Manor Farm Options Report for Lower Thames Crossing

Prepared for Stuart Mee

This report sets out the water balance issues facing Stuart Mee at Manor Farm, and some potential options to present to the Lower Thames Crossing Project Team. All options are presented without prejudice and to aid discussion between all the parties involved. No party should be held to account based on the recommendations.

Figure 2: Map of the proposed like-for-like and insurance elements of the option. New elements are in orange.

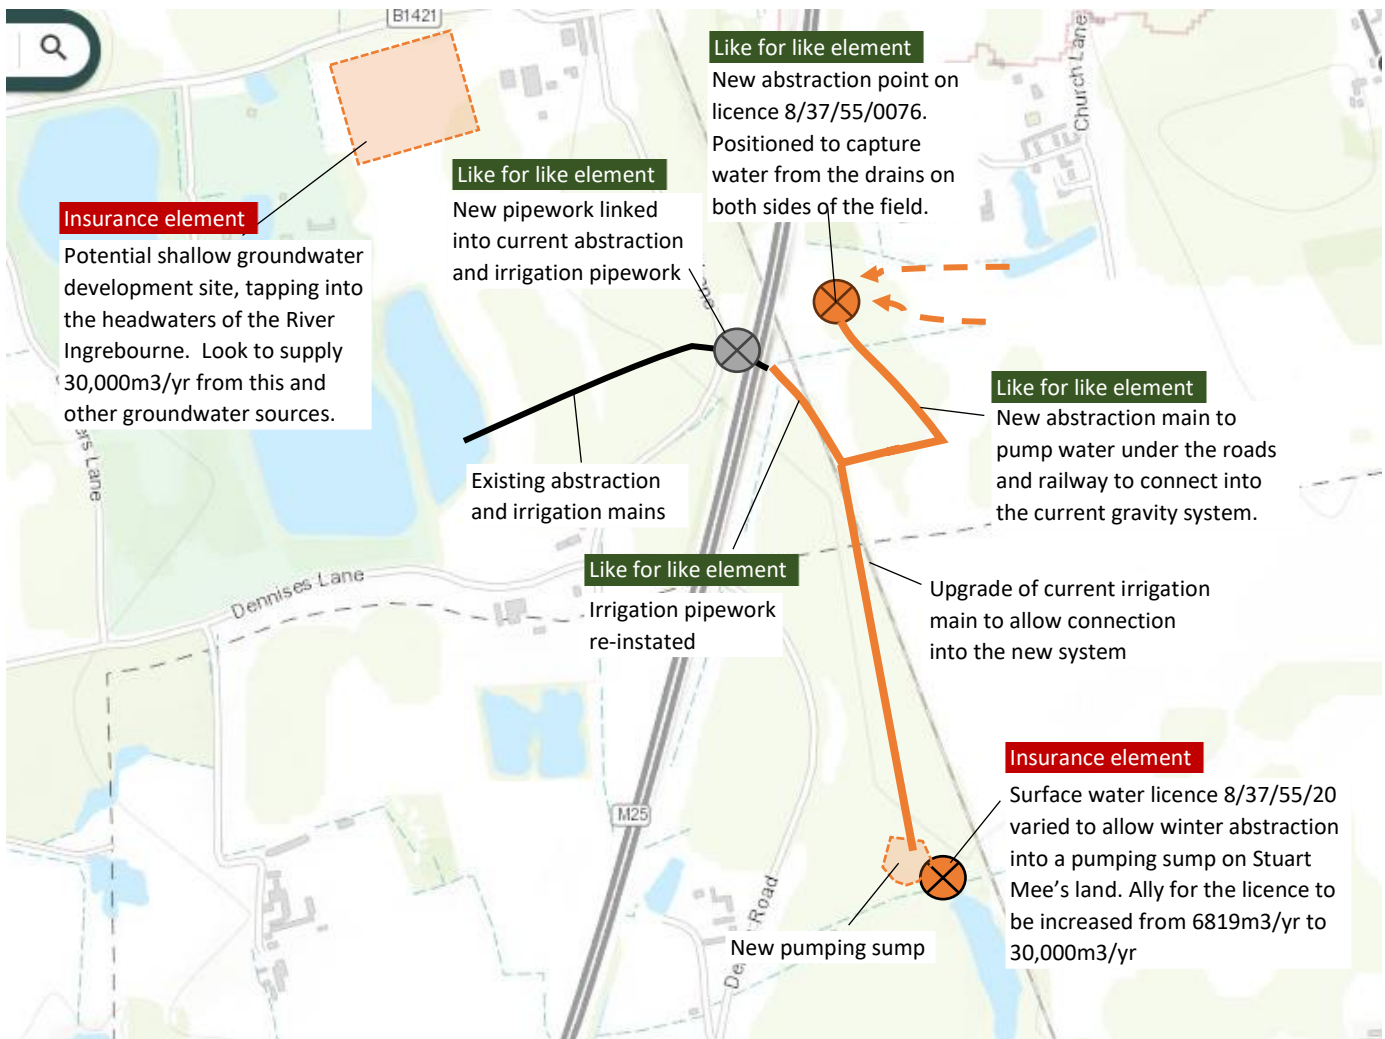
This will mean re-locating of the abstraction point on licence 8/37/55/0076 to the east of the proposed new road. At the new abstraction point, water would be directed into a pumping sump before being pumped around the new and existing roads/railway, and into the current gravity system that runs west of the road to the reservoir. (see Like-for-like elements in green on Figure 2)

- It is possible that some of the drainage from the banks of the current M25 road may no longer be captured at the new abstraction point.
- Water that currently runs along the drains at the southern boundary of the catchment are likely to be disrupted by the construction of the new road, or potentially directed away from the new abstraction point.

- Where possible LTC look to direct drainage from the new road into ditches that supply the catchment to the abstraction point.
- That the drains on the southern boundary of the catchment are considered when positioning the new abstraction point in order that this part of the resource is maximized.
